PRODUCT CHANGE | DRIVE FOR 45mm MOTOR IN 2.5 & 3.25" TUBE

| | DISCONTINUED PRODUCT | | REPLACEMENT PRODUCT | CHANGES MADE | |
|----------------|---|------------------------------------|--|-------------------------------------|-------------------------------------|
| IMAGE. |  | |  | <input checked="" type="checkbox"/> | <input type="checkbox"/> |

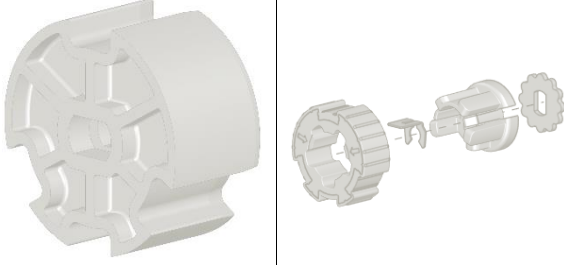
| | DISCONTINUED PRODUCT | | REPLACEMENT PRODUCT | CHANGES MADE | |
|----------------|---|------------------------------------|--|-------------------------------------|-------------------------------------|
| DESCRIPTION. | Drive for 45mm motor in 2.5" Tube | Drive for 45mm motor in 3.25" Tube | Drive for 45mm motor in 2.5" & 3.25" Tubes | <input checked="" type="checkbox"/> | <input type="checkbox"/> |
| CODE. | MTDR-45-2.5 | MTDR-45-3.25 | RB24-0163-050001 | <input checked="" type="checkbox"/> | <input type="checkbox"/> |

- Reduced number of components results in quicker fabrication time.
- Rubberized over mould drive construction improves sound transference
- Reduces shade minimum width for 3.25" applications
- Reduced cost for 3.25" applications

- Fewer SKU's for Fabricators
- Minimum Width Reduction for 3.25" Tubes
- Drive Clip Sold Separately
